# **SERVICE BULLETIN**

M-1072 AUGUST 21, 1998

# FLTR (ROAD GLIDE) HEADLAMP ASSEMBLY MOUNTING CLIPS

Figure 1. Headlamp Adjuster Hole (Left Side)

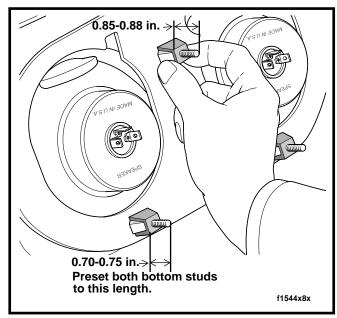
This Bulletin gives information on improved headlamp assembly mounting clips, Part No. 67981-98A. The new clips have been used in late 1998 production and all 1999 production. The new clip is **black**; the old clip, Part No. 67981-98 is **green**. If you encounter a loose headlamp assembly, replace the three green clips with the new black clips. The following procedure provides instructions for this repair.

See Figure 1. To check what clips are installed, shine a light into the adjuster hole and check the color of the clip.

- Refer to Section 2 of FLT Service Manual. Remove outer fairing.
- 2. Refer to Section 8 of FLT Service Manual. Remove headlamp assembly from fairing.
- Unscrew and remove old green clips from hex adjuster studs.
- 4. Install new black clips on hex adjuster studs.
- Install headlamp assembly in outer fairing.
- See Figure 2. Preset hex adjuster studs to the lengths shown.
- 7. Refer to Section 2 of FLT Service Manual. Install outer fairing.
- Refer to Section 8 of FLT Service Manual. Check, and if necessary adjust headlamp beams.
